TTI Performance Exhaust and Headers
Tube Technologies, Inc.
Corona, California 92880-1726
Phone (951) 371-4878

Sheet #101 / Footnote #36

3-section throttle rod swivel assembly modification

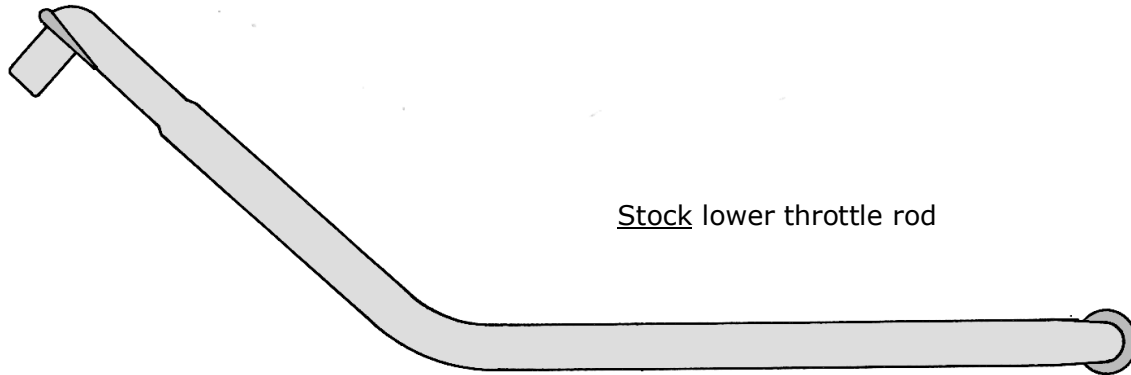
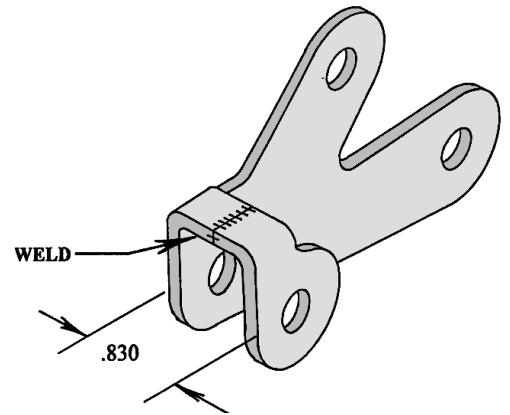
Applications with a 3-section throttle rod may require modification to the bell-crank and the pivot shaft to clear the header tubes or exhaust pipes.

Big Block Headers: Modification may be required when installing some headers.

Exhaust-pipes (to stock manifolds): Modification will be required when installing listed pipes; A25LE, E25LE3 and E30LE3.

1. The bell-crank and the pivot shaft must be shortened by 3/4".
2. Weld the bell-crank back together as shown.
3. Re-bend the lower throttle rod as shown.
